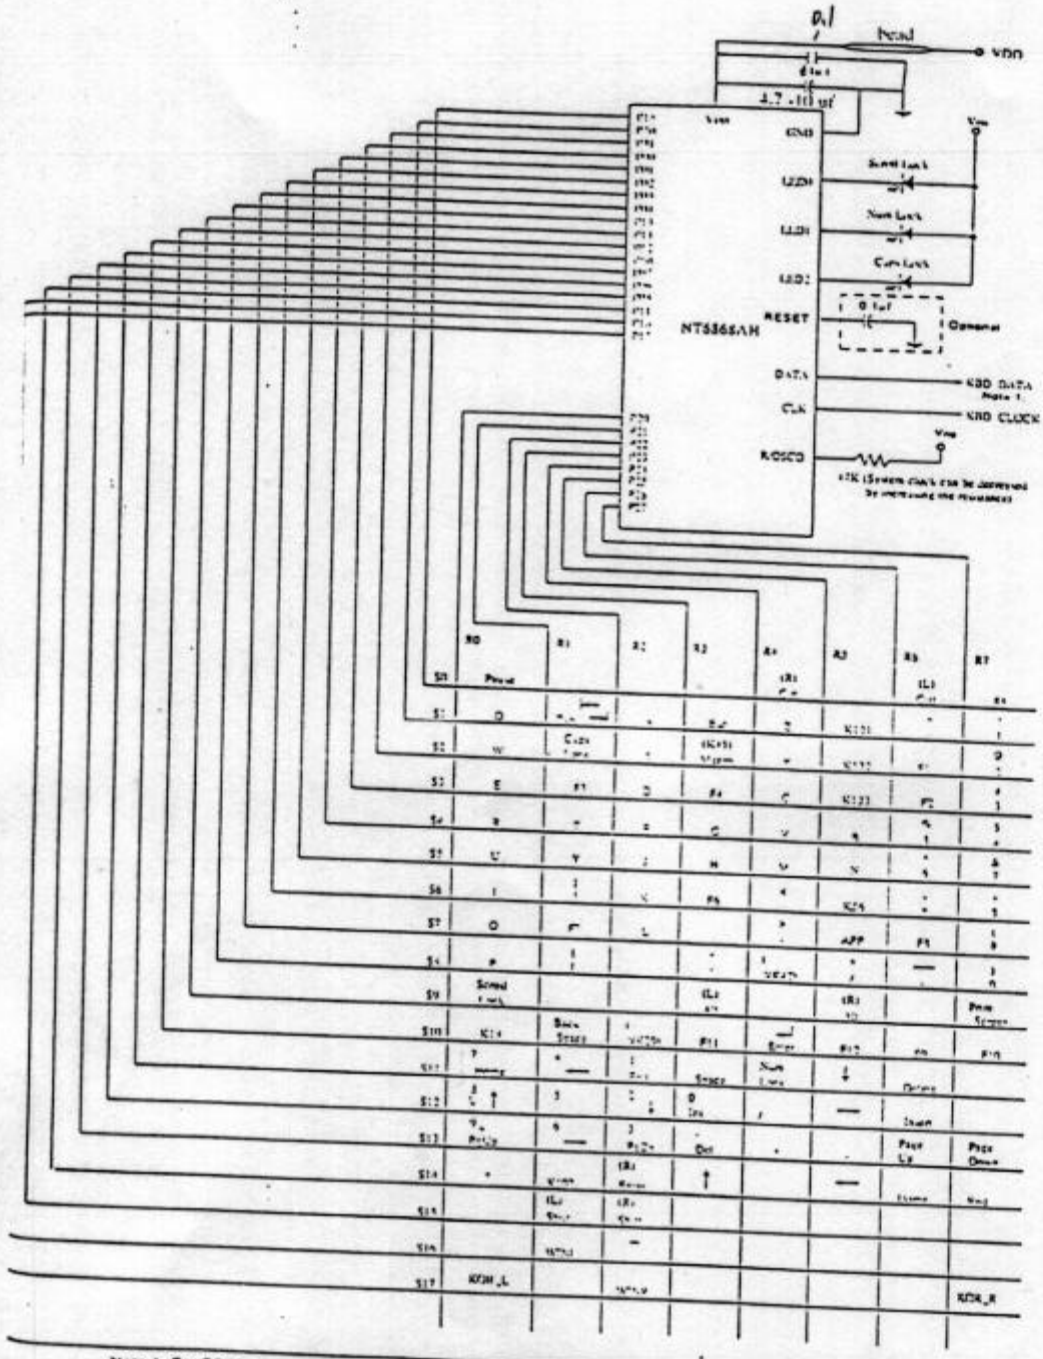
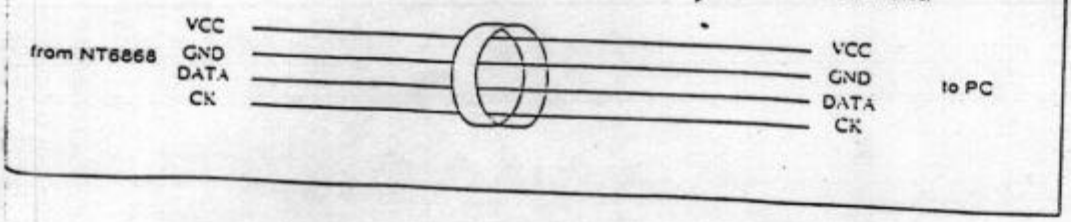
Note 1. For FCC approve, please add an ngh type of bead for the signal wire can go though inside of the bead.
